PLANNING APPLICATION - F/23/95844 - Full planning

Title: Proposed Suitable Alternative Natural Greenspace (SANG)

Address: LAND AT STOKE PARK FARM, BISHOPSTOKE, EASTLEIGH, SO50 6DW

The following document is the response to the updated Transport Assessment B062 75-CLK-XX-XX-RP-T A-001 P6 (29/09/23) - Charlotte Kersley, 4 Gilbert Avenue, Bishopstoke, Eastleigh SO50 6JG which needs to be addressed before proceeding with the next stage of this proposed development.

I-transport FIGURE 3.2 - Stoke Park Farm, Bishopstoke

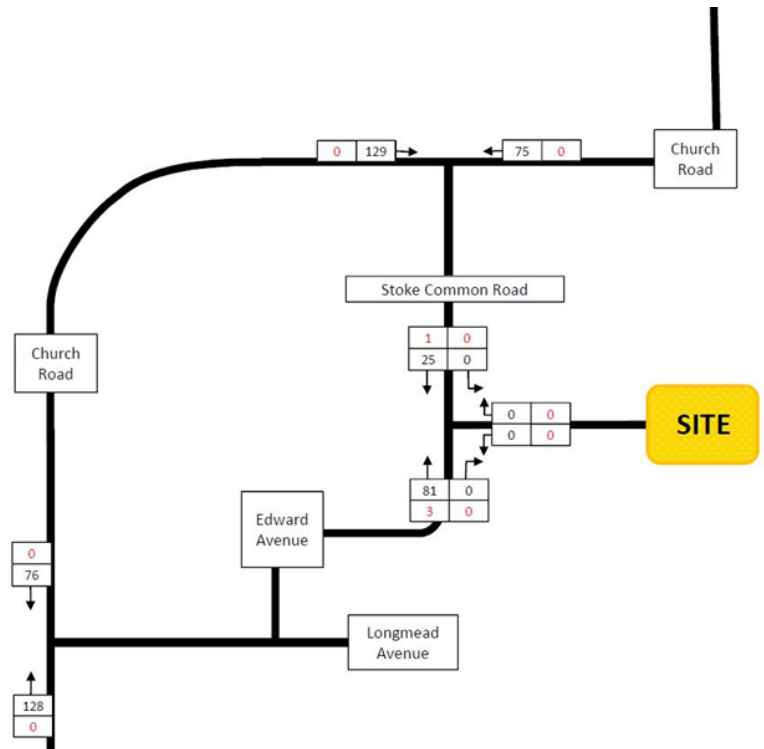
This document i-Transport Ref: EP/DF/ITB8277-003A R (06 November 2013) conducted an Automatic Traffic Count (ATC) survey, which was undertaken on Stoke Common Road in the vicinity of the proposed site access (Sewall Drive) for the week-long period from 9th March 2013 to 15th March 2013. This established the baseline traffic flow on Stoke Common Road at the proposed site access junction (Sewall Drive).

These plans below show the baseline traffic flow for AM & PM, it can clearly be seen that no traffic entered or left the site entrance (Sewall Drive). I have embedded this information into this document for ease of understanding.

AM Peak Hour - **NO VEHICLES INTO OR OUT OF SITE**

I-transport FIGURE 3.3 - Stoke Park Farm, Bishopstoke

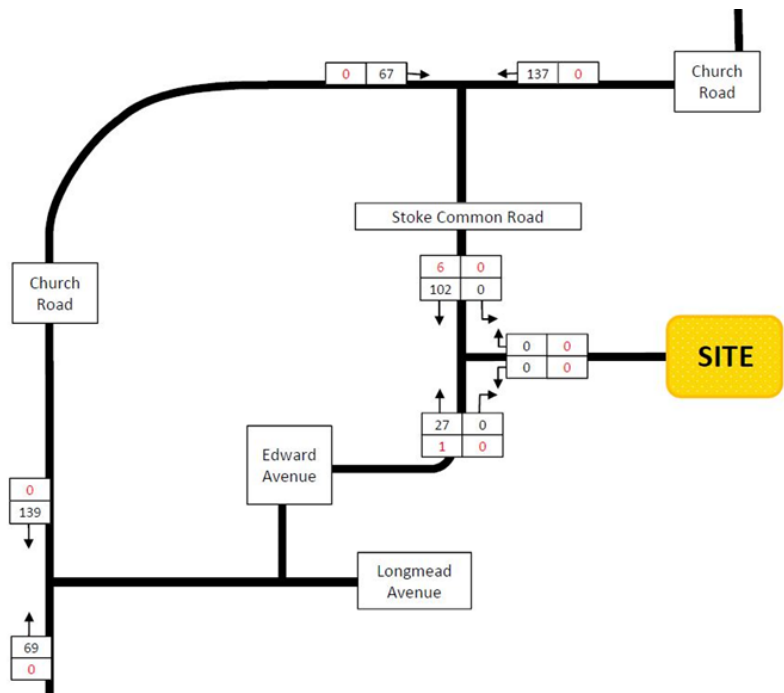
PM Peak Hour - **NO VEHICLES INTO OR OUT OF SITE**
